Keeyask Generation Project Environmental Impact Statement

Responses to Information Requests -
CEC, Round 2

**Re: KEEYASK GENERATION PROJECT - RESPONSES TO SECOND ROUND OF CEC
INFORMATION REQUESTS FROM HEARING PARTICIPANTS**

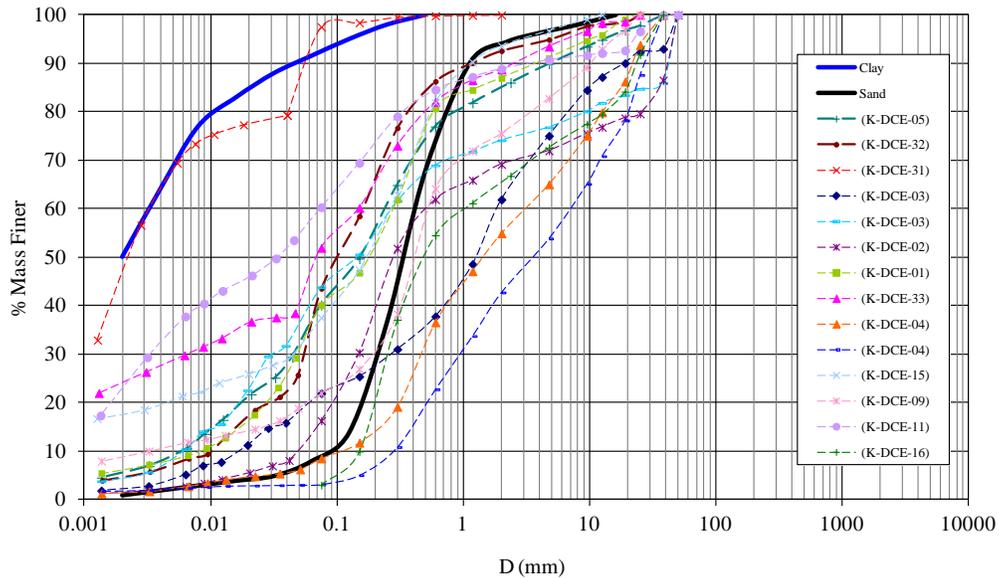
139 The transport of cohesive sediment is discussed in Technical Memorandum GN-9.2.10
 140 (Section 6.3.3). As discussed in this memorandum, the transport of cohesive sediment is
 141 rather complex due to the electrostatic and electrochemical forces that bind sediment
 142 particles together. These forces make erosion and sediment transport of cohesive
 143 material fundamentally different from the transport of non-cohesive particles. In HEC-
 144 RAS, there are two methods to calculate cohesive sediment transport:

168 Based on the discussions made above on the applicability of the model and the relevant
169 equation as well as due to the built-in conservative approach taken in the analysis, the
170 Partnership is of the view that the model results are not seriously flawed.

Figure 1. Dominant surface materials in the Lower Nelson River region.
Source: Fulton (1995).

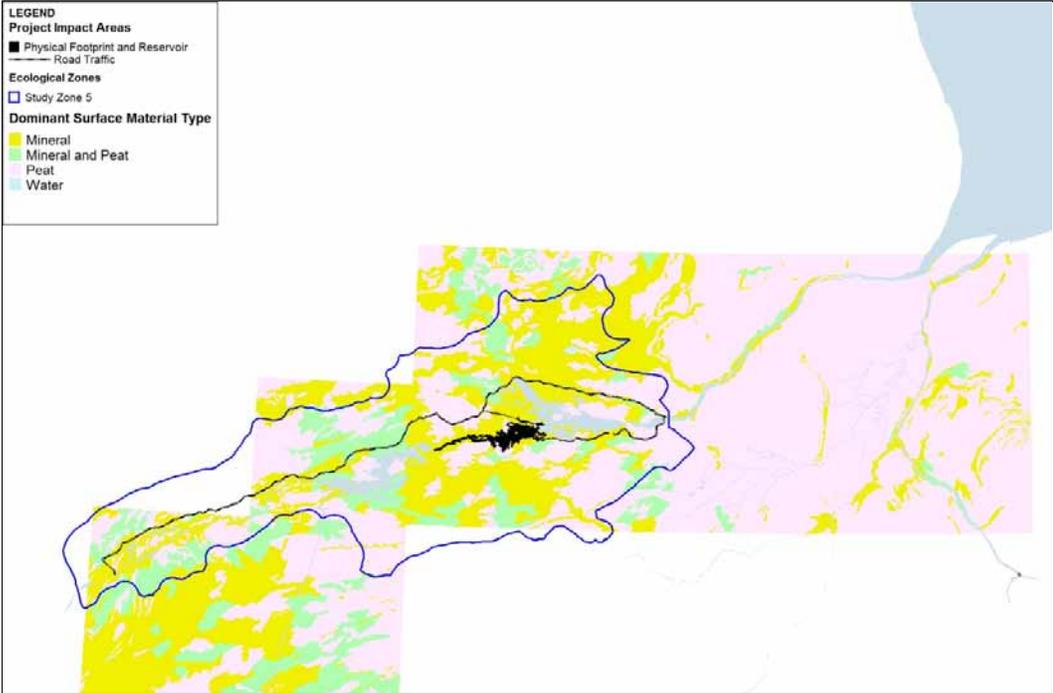
186 The distinct ecological boundary produced by the Tyrrell Sea marine deposition zone
 187 (Figure 1) is a strong ecological basis for delineating the eastern boundary of the
 188 regional ecosystem, as well as the study zones used for the other VEC Regional Study
 189 Areas. This boundary generally coincides with where the Hudson Plains Ecozone meets
 190 the Boreal Shield and Taiga Shield Ecozones in the Keeyask area (Ecological Stratification
 191 Working Group 1996). It is clarified here that the eastern boundary of Study Zone 5 was
 192 delineated based on changes in dominant ecological conditions as opposed to using an
 193 Ecozone boundary. In fact, portions of the Ecozone and Study Zone 5 boundaries
 194 coincide for the same reason.

Figure 3. Population ranges for hypothetical caribou herds, and their relation to a project's impact areas.

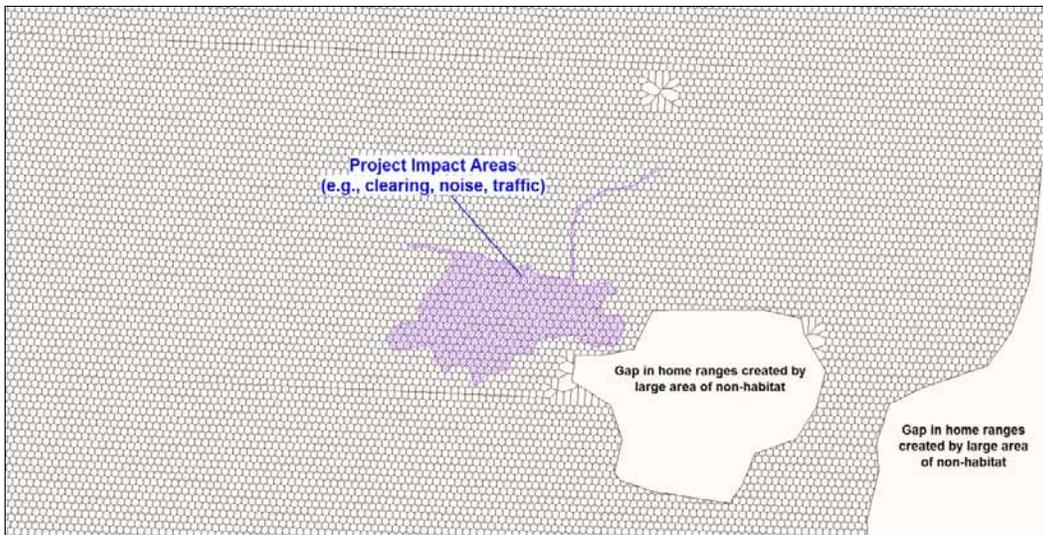
299 On this basis, the assessment evaluates the VEC populations directly affected by the
300 Keeyask Project, rather than using a study area delineated by the locations of all past,
301 current and future projects to assess effects on VECs. When applying the VEC-centric
302 approach used in the terrestrial assessment, another project or development does not
303 have to be physically located within a VEC's Regional Study Area in order for effects
304 from that development to be evaluated as a cumulative effect with the Project.
